## REVISED RESPONSE TO REQUEST FOR ADDITIONAL INFORMATION

### APR1400 Design Certification

Docket No. 52-046

**RAI No.:** 129-8085  
**SRP Section:** 03.08.01 –Concrete Containment  
**Application Section:** 03.08.01  
**Date of RAI Issue:** 08/05/2015

Figure 5-4 Containment Pressure for Loss of RHR (Mode 5)

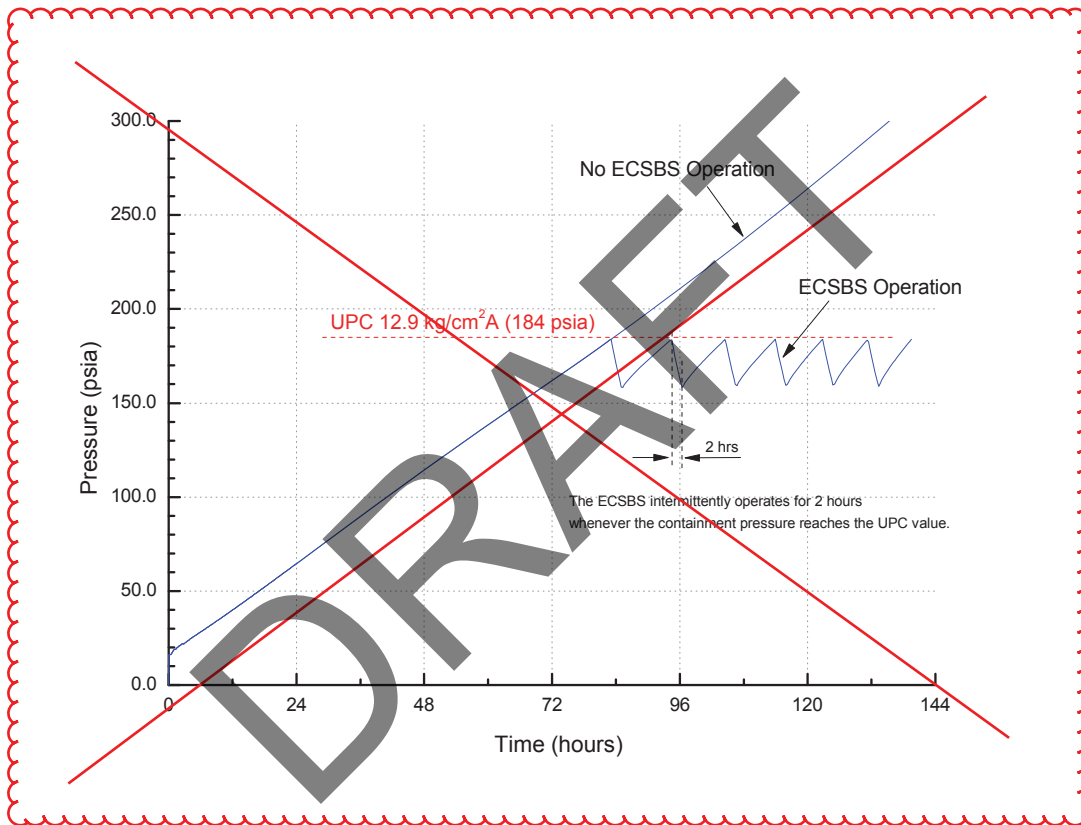
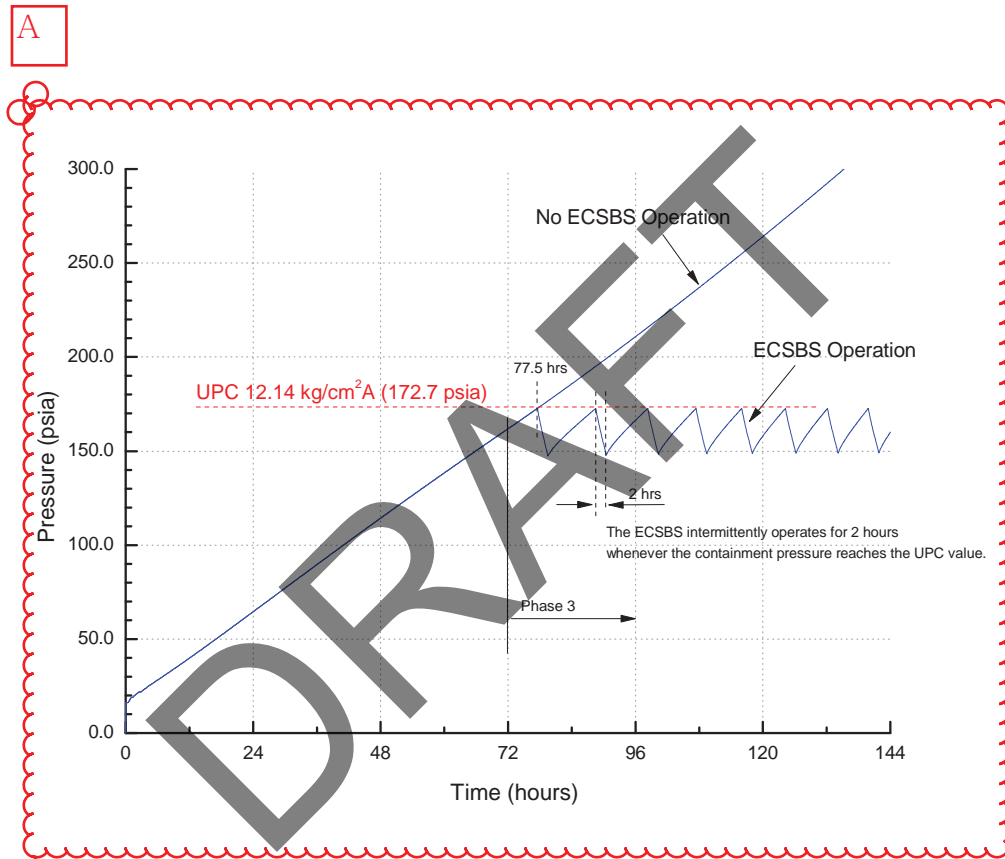
Technical Report "Evaluations and Design Enhancements to Incorporate Lessons Learned from Fukushima Dai-Ichi Nuclear Accident" (APR1400-E-P-NR-14005-P/NP, Rev. 0), Sections 5.1.2.3.3.3, 5.1.2.3.4.6, 5.1.2.5.3, and Figures 5-4 and 5-5 will be revised, as indicated in the attachment associated with this response.

Replaced with next page, A

Due to the mass and energy released from the RCS, containment pressure increases consistently from the beginning of the event, but it can be maintained below UPC by operating the ECSBS intermittently after reaching UPC at around 83 hours. The ECSBS is assumed to start spraying water into the containment atmosphere via a FLEX pump when the containment pressure reaches the UPC value of 12.9 kg/cm<sup>2</sup> A (184 psia). After the initial operation, the ECSBS is assumed to be intermittently operated for 2 hours whenever the containment pressure reaches the UPC value. The FLEX pump provides the flow rate of 2,839 L/min (750 gpm) and the differential pressure of at least 2.8 kg/cm<sup>2</sup> (40 psi) at the ECSBS nozzle. The external water source for ECSBS operation is the RWT.

GOTHIC analyses are performed for evaluation of the containment pressure and temperature responses following loss of RHR in mode 5. Figure 5-4 shows that the containment pressure reaches the UPC value in about 3.5 days without ECSBS operation, but with the intermittent operation of ECSBS, containment pressure can be maintained within the UPC limit. Figure 5-5 shows that the containment temperature is maintained well below 185 °C (365 °F), which is less than the upper limit temperature of 196 °C (385 °F) for ensuring the operability of RCS sensors.

Figure 5-5 Containment Temperature for Loss of RHR (Mode 5)

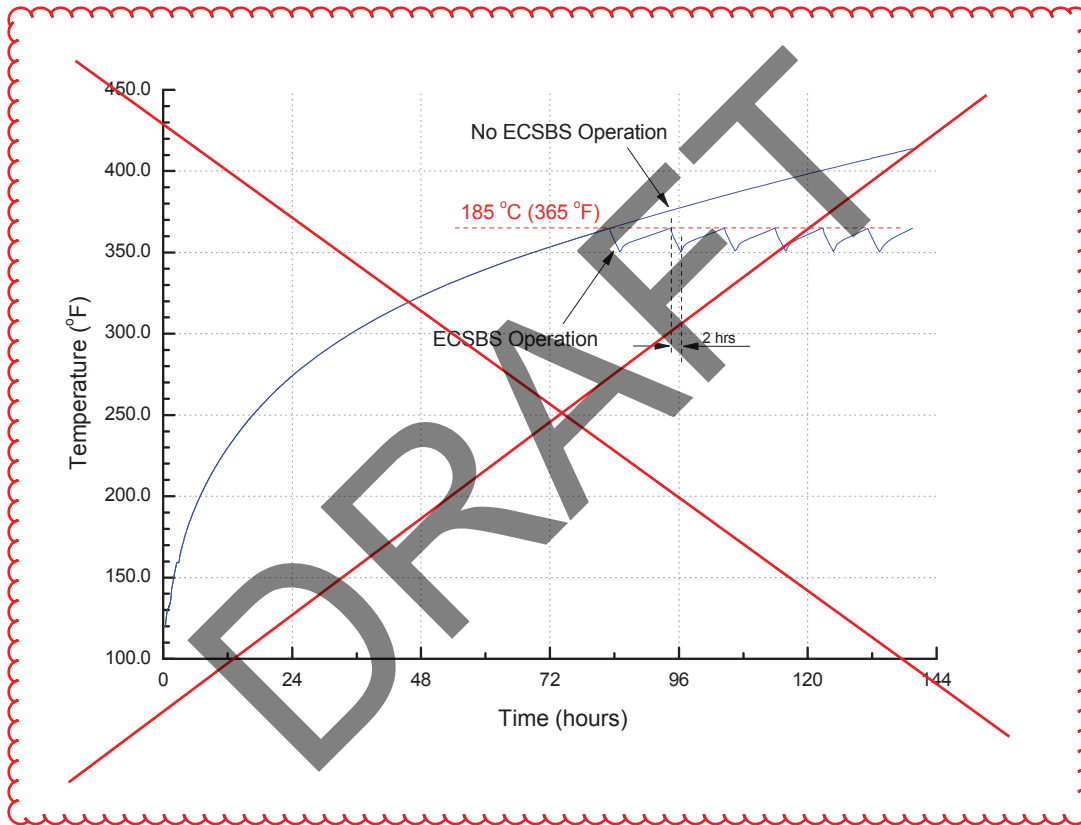
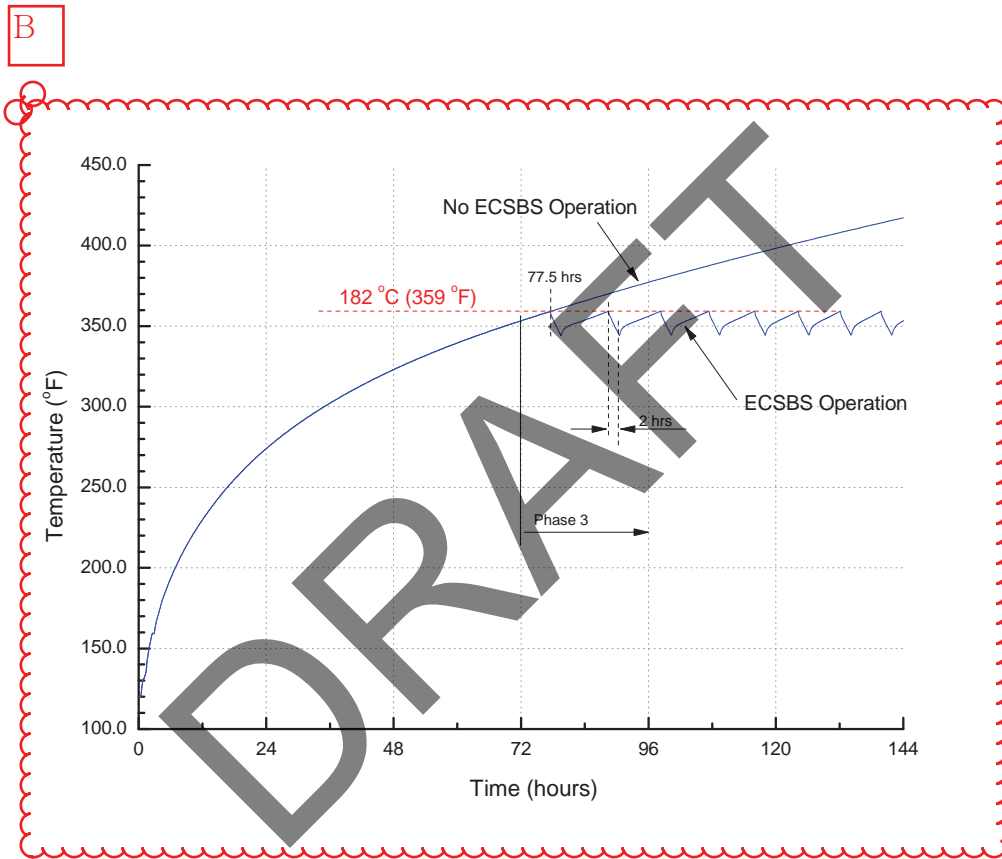
Replaced with next page, B
